## CITY OF GLENDALE, CA

### DESIGN REVIEW STAFF REPORT – SINGLE FAMILY

<b>December 21, 2023</b> <i>Decision Date</i>	<b>2427 Hollister Terrace</b> <i>Address</i>
<b>Administrative Design Review (ADR)</b> <i>Review Type</i>	<b>5666-007-026</b> <i>APN</i>
<b>PADR-000985-2023</b> <i>Case Number</i>	<b>Armen Hogtanian</b> <i>Applicant</i>
<b>Chloe Cuffel, Planning Associate</b> <i>Case Planner</i>	<b>Ben Betts</b> <i>Owner</i>

The project proposes a 510 square-foot addition at the rear of an existing two-story, 2,925 square-foot single-family dwelling (built in 1931) with a detached 492 square-foot garage located on a 7,340 square-foot lot. The proposed addition will be on the second-story, replacing an existing attic space and contained within the existing envelope of the house. The front façade will also be remodeled to repair the existing balcony, and no style changes will be made.

rear elevation 1

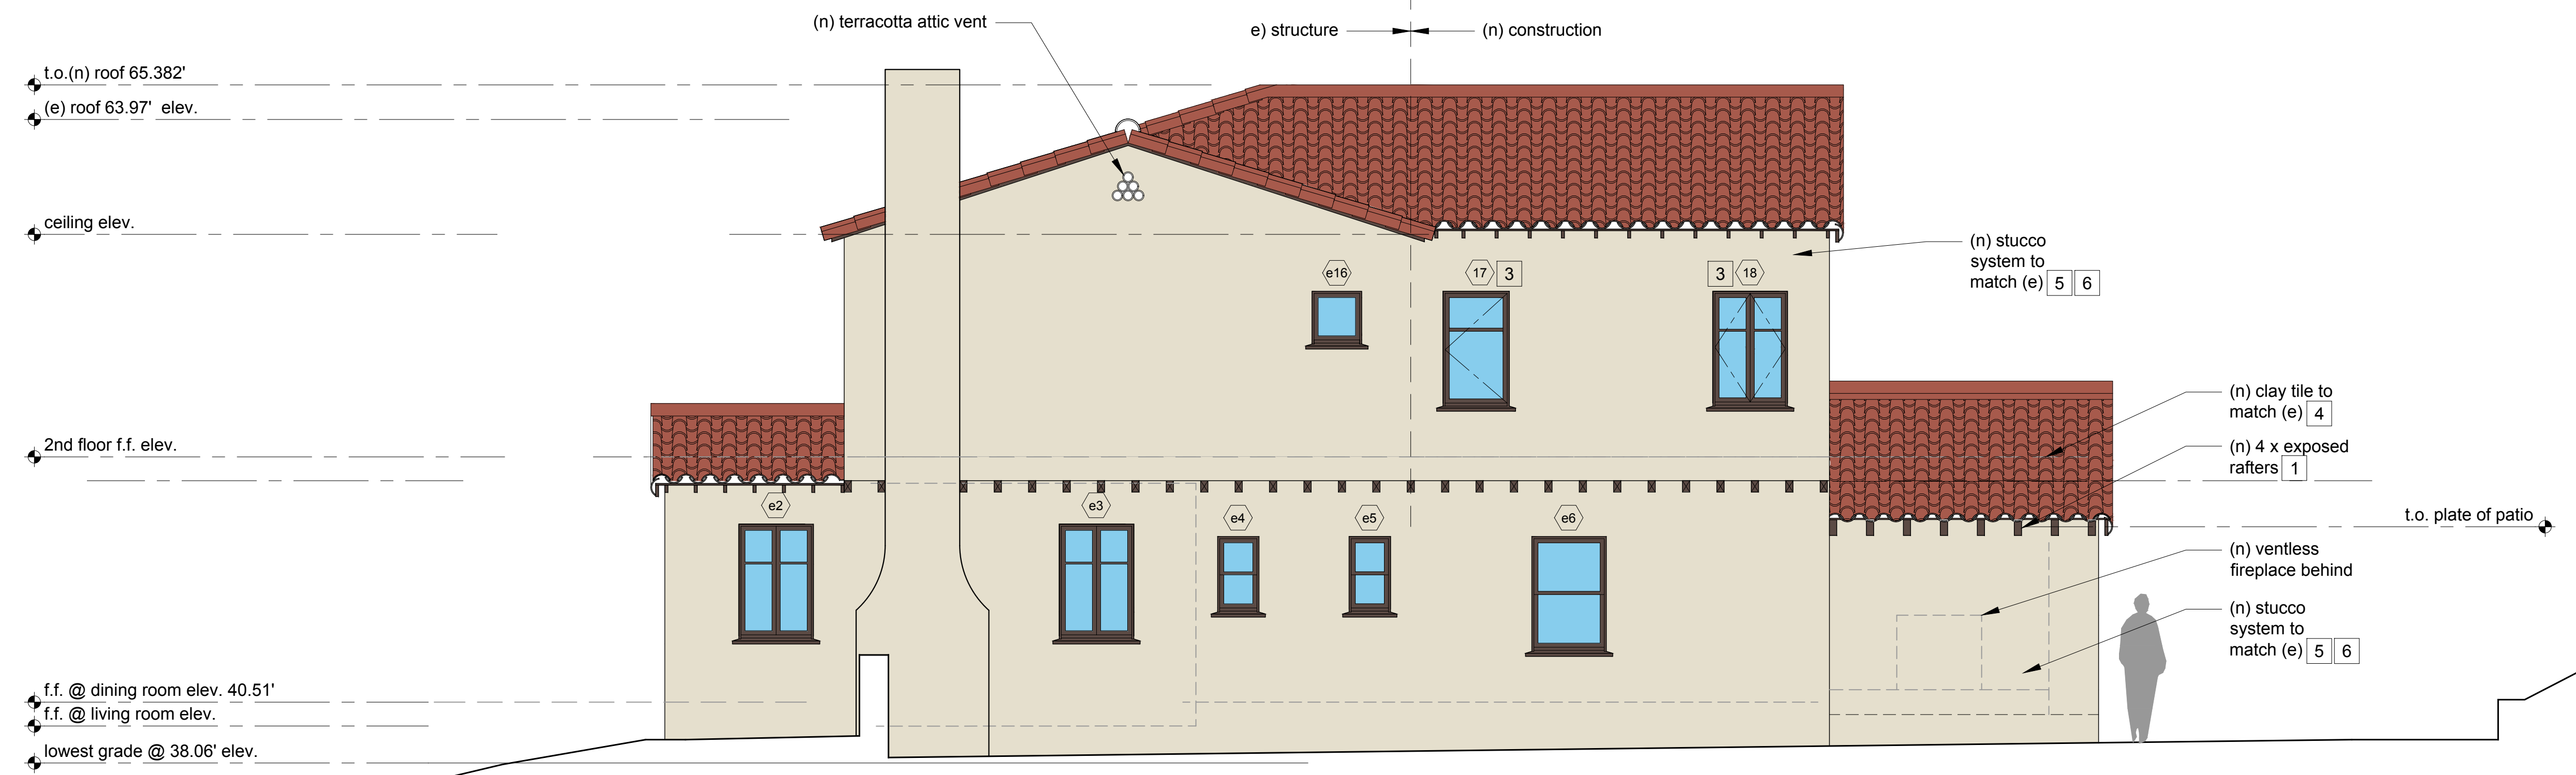
- Red clay roof tiles are proposed for the addition to match existing.
  - The wood railings on the proposed west-facing balcony will match the existing railing at the front of the house. This balcony could pose privacy concerns to the neighboring single-story house.

**window type**

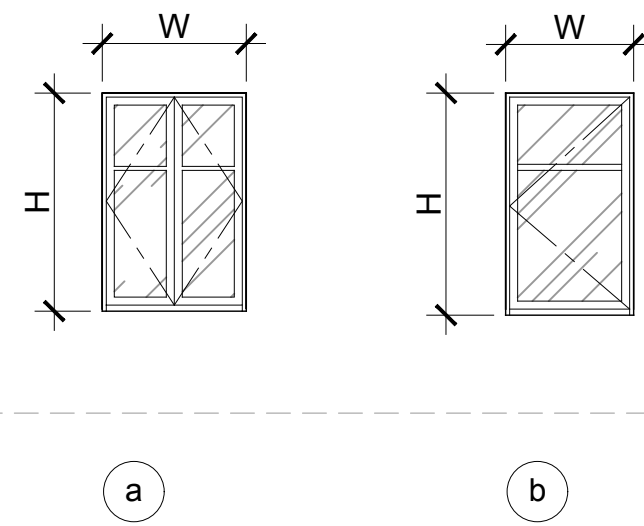
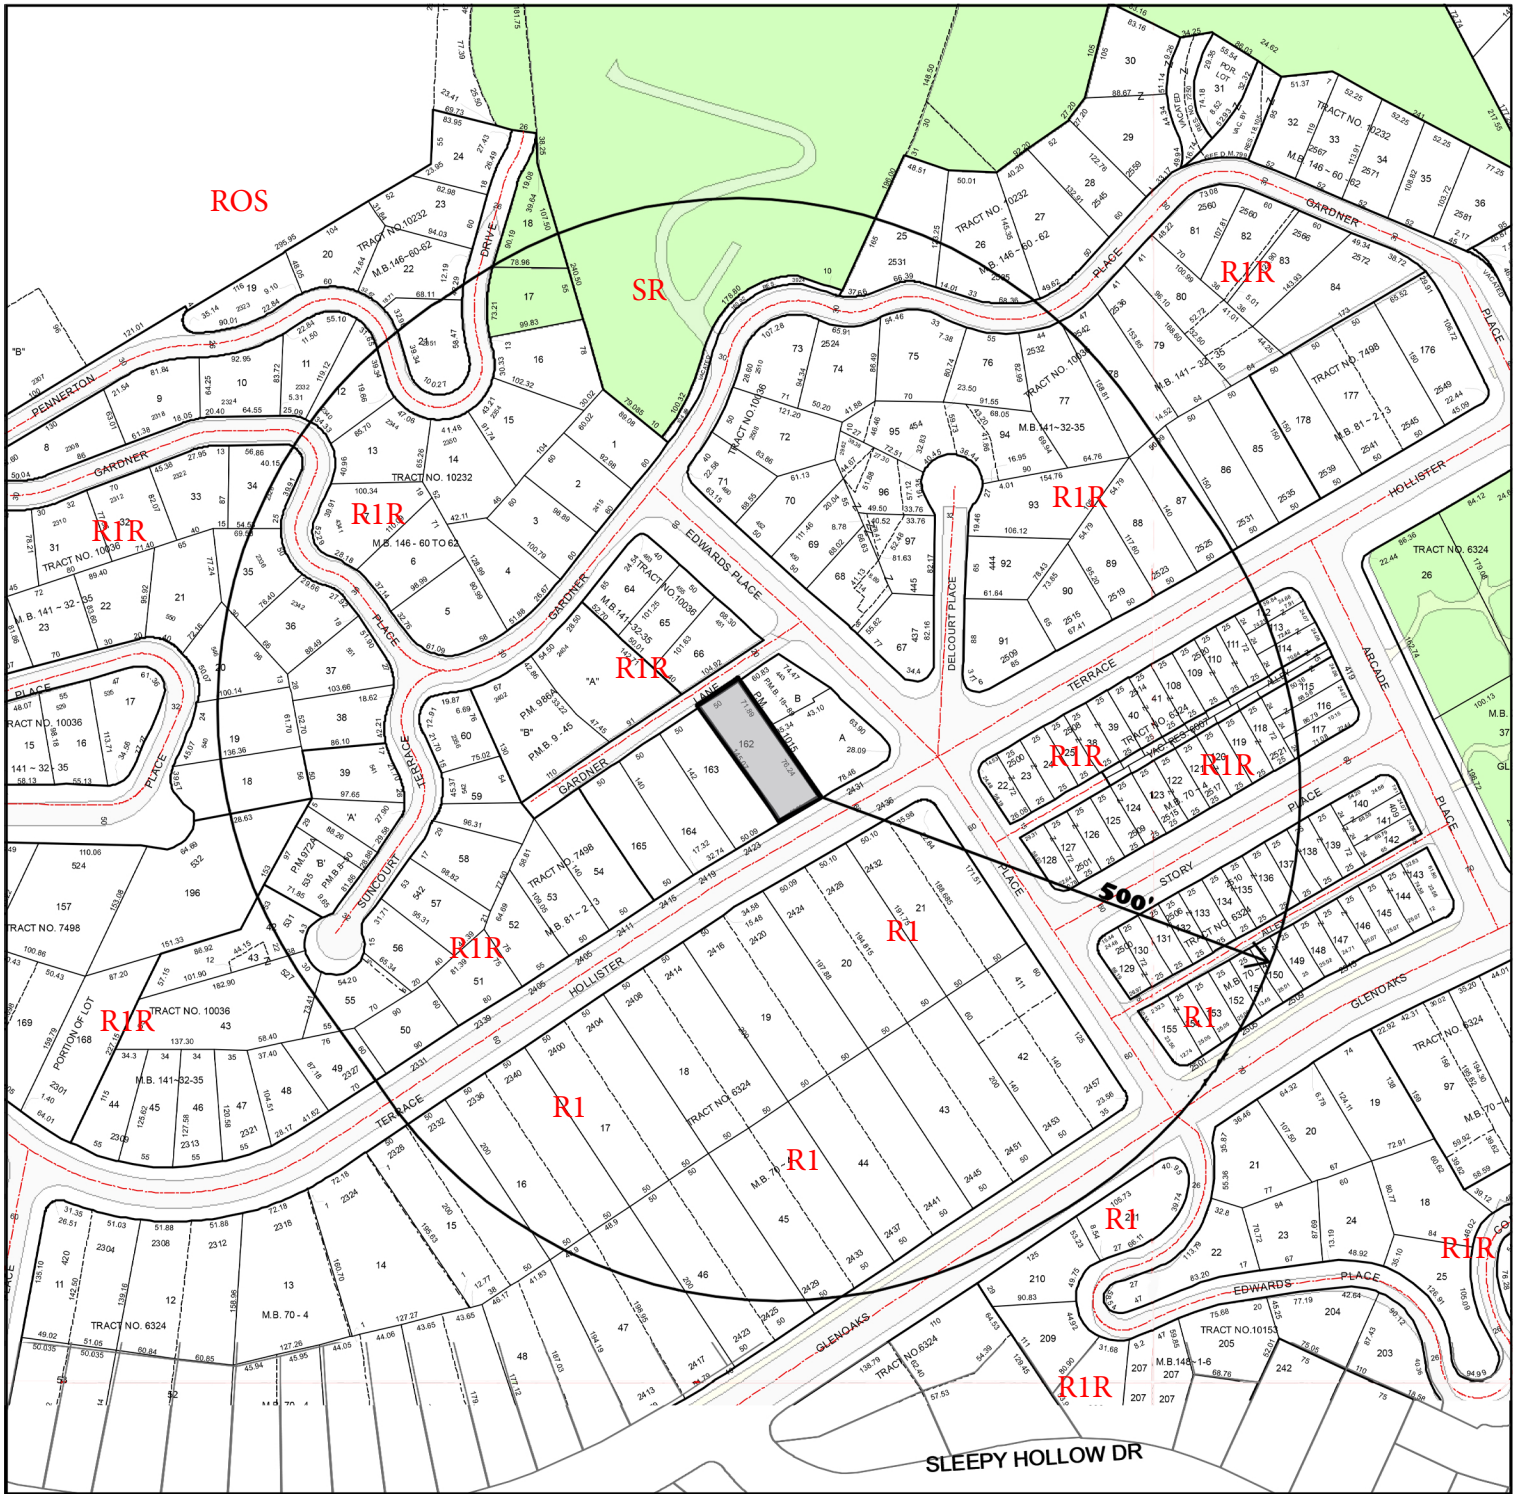
- The finish materials are appropriate to the style including stucco finish, wood-clad windows and terracotta attic vents.
  - The new windows for the addition are wood-clad and feature casement operations. The new windows will match the pattern of the existing windows, including the wood mullions. A condition is included to revise the window schedule to show complete details of frame type and provide a window section drawing.

1. That the window schedule be revised to show frame type and window sections.
  2. That specifications (cut sheets) for the exterior lighting fixtures on the new building and locations shall be submitted for staff review and approval prior to plan check submittal. The exterior lighting should be appropriate to and consistent with the style of the addition and their locations should be limited to the main entry and patio doors.
  3. That the gutters shall be painted to match the adjacent wall color.
-
